ISSUE 5	ISSUE 4	ISSUE 3	ISSUE 2
	Electronic Foot-Switch Facility Added. See Note	RICHICOLA+ WAZ 4TOR C1 WAS100p	C50 AN011 XANS R2
28-8-86SH	17-4-8418	27-6-8	WP

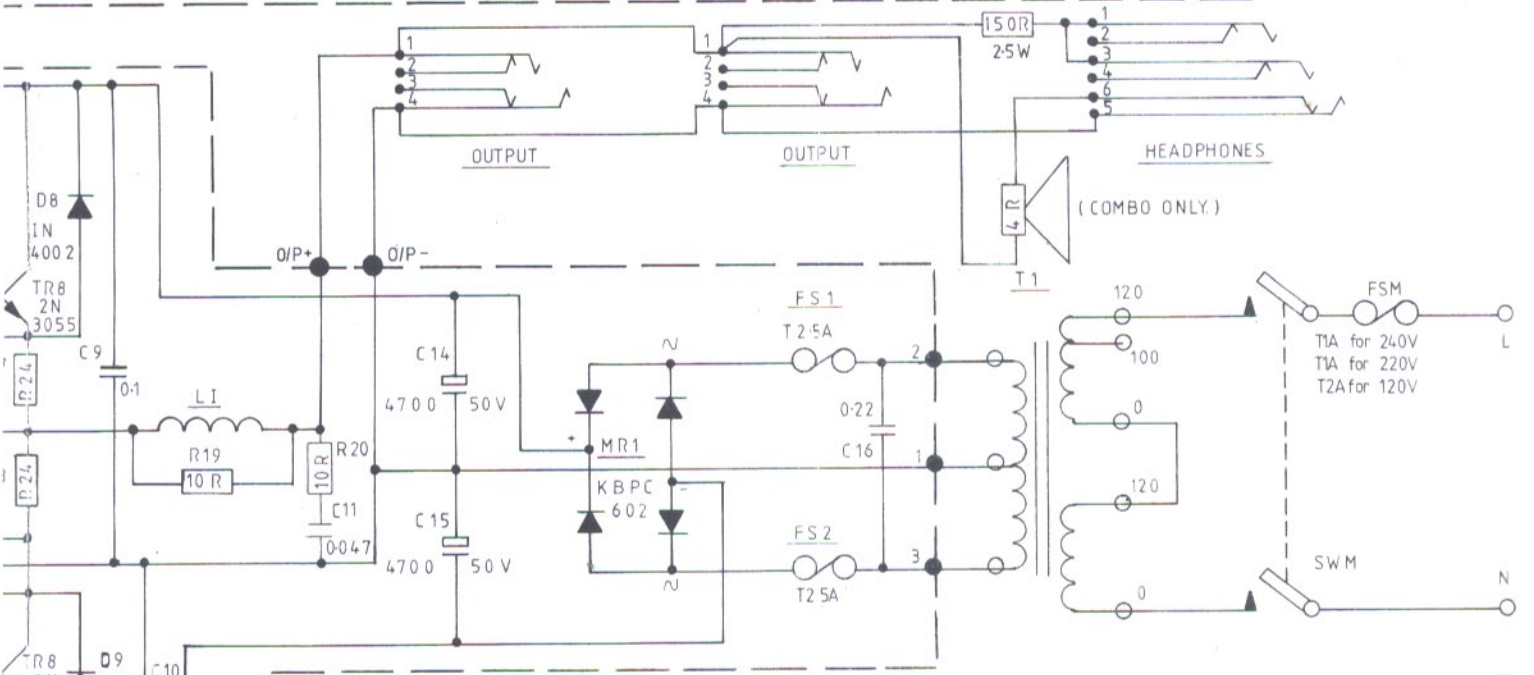
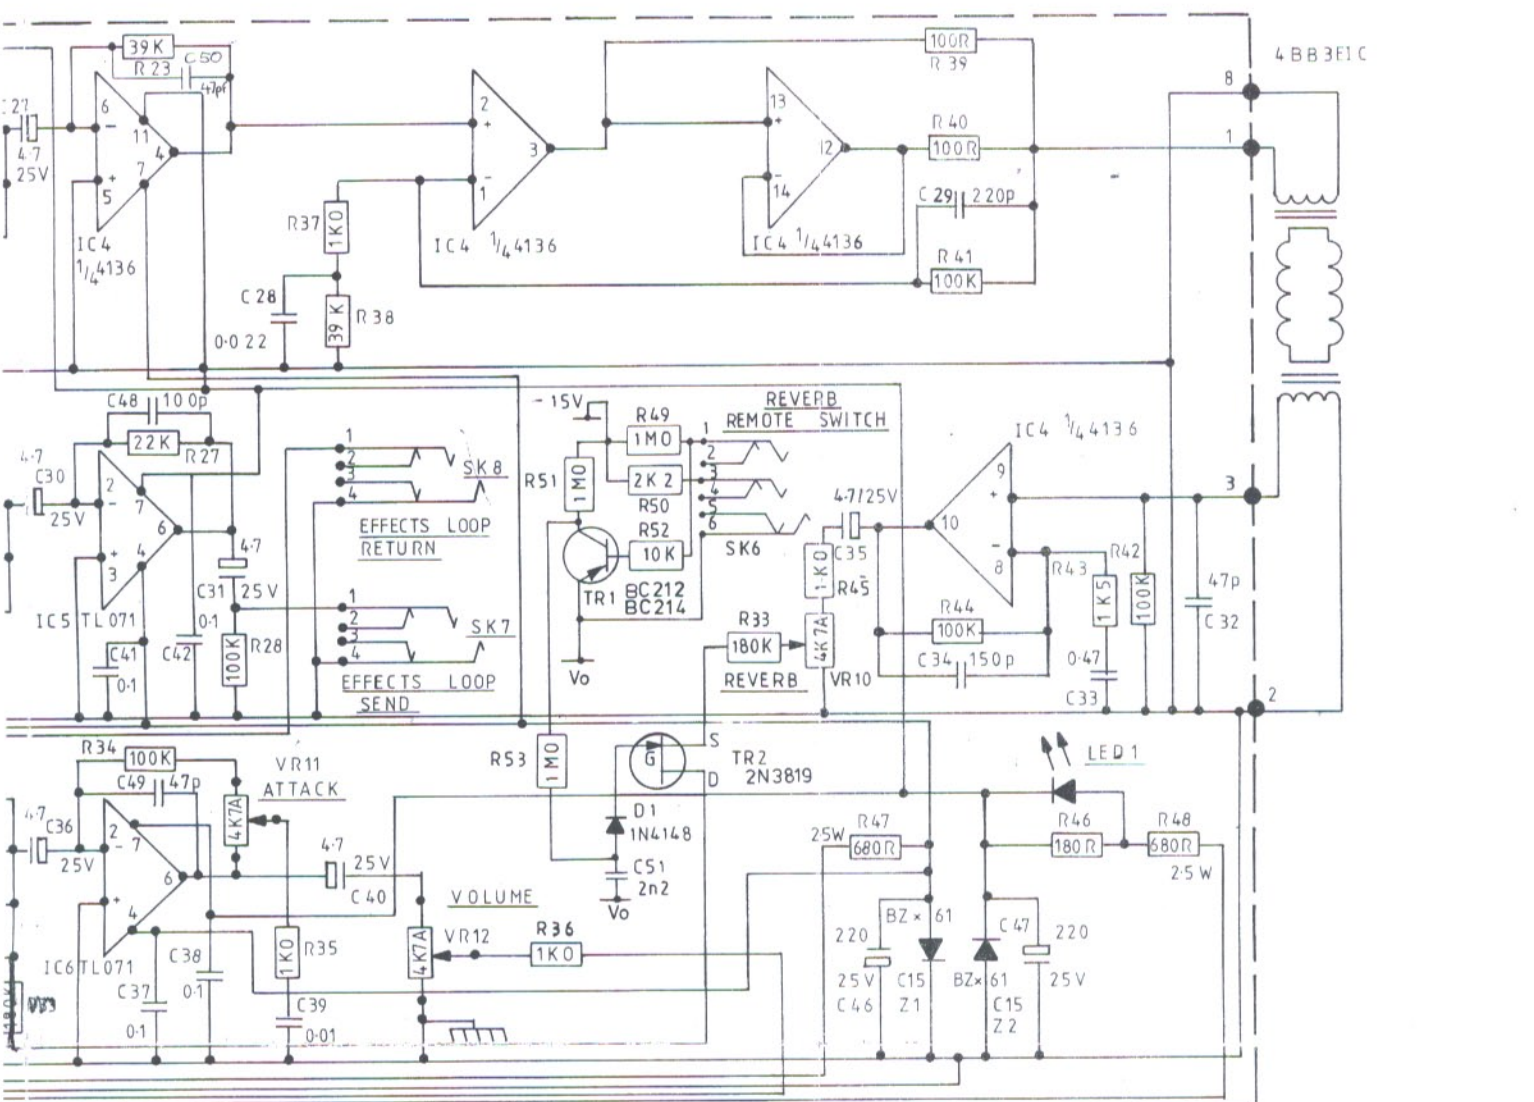
COMPONENTS ADDED FOR ELECTRONIC FOOTSWITCH FACILITY	
R50 - 2K2	TR1 - BC212
R49, R51, R53 - 1M0	TR2 - 2N3819
R52 - 10K	D1 - IN4148
C51 - 2n2	SK6 WAS MONO NOW STEREO
